APPLICATION NO.	FILING DATE	FIRST NAMED INVENTOR	ATTORNEY DOCKET NO.	CONFIRMATION NO.
10/099,775	03/15/2002	Jean-Christophe Jacques Kling	3206.2.1 NP	4985

Office Action Summary

DETAILED ACTION

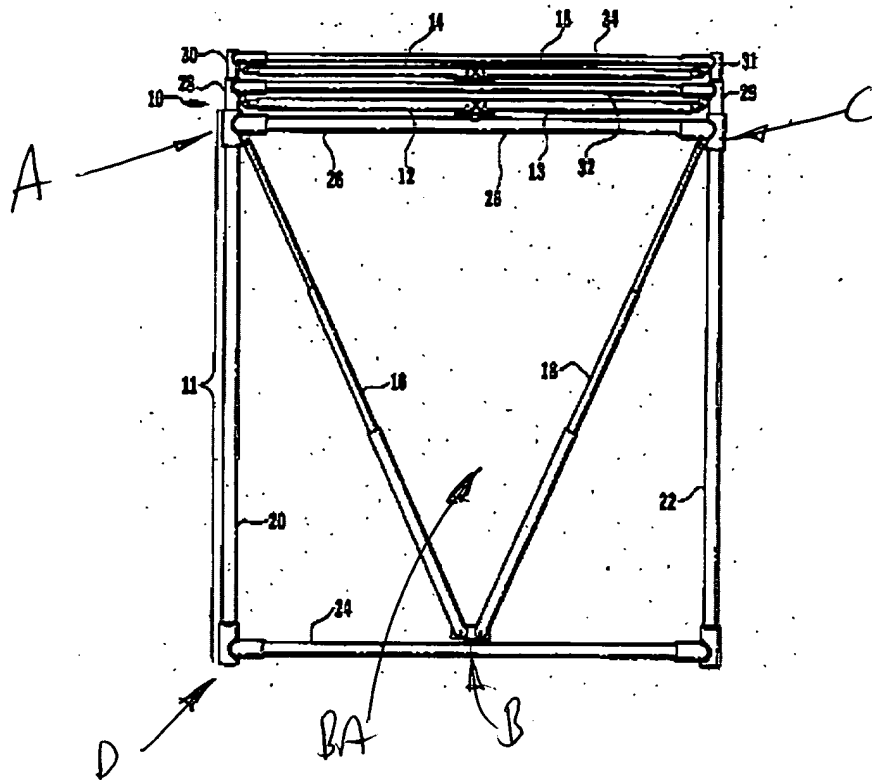
Claims 1-24 are rejected under 35 U.S.C. 103(a) as being unpatentable over US Patent #4,604,844 to MIKULAS, Jr. et al. MIKULAS, Jr. et al. discloses the use of an architectural system (10) including a triangular base (BA) consisting of a first (16), second (18) and third (26) strut aligned along first (AB), second (BC), and third (CA) axis; such that the first and third struts (16,26) form a first acute base angle (CAB), the first and second (16,18) struts form a second acute base angle (ABC), and the second and third struts (18,26) form a third acute base angle (BCA), see below; wherein the

struts (16,18) each consist of at least two rigid pieces (column 2, line 67 to column 3, line 2) movable apart to form a strut elongation. The structure (10) further includes a first node (A) engaging the first (16) and third (26) struts, a second node (B) engaging the first (16) and second (18) struts, a third node (C) engaging the second (18) and third (26) struts, and an extension (20,22,24) (28,30) and (29,31); wherein the extensions (20,22,24) (28,30) and (29,31) consists of fourth struts that engage the triangular base (BA), see the marked attachment. MIKULAS, Jr. et al. discloses the basic claimed structure except for explicitly detailing the exact dimensions of the angles forming the base triangle or the angle of the fourth strut. Although MIKULAS, Jr. et al. does not detail explicit angles that form the base triangle, it would have been obvious to one having ordinary skill in the art at the time the art was made to select an angle dimension
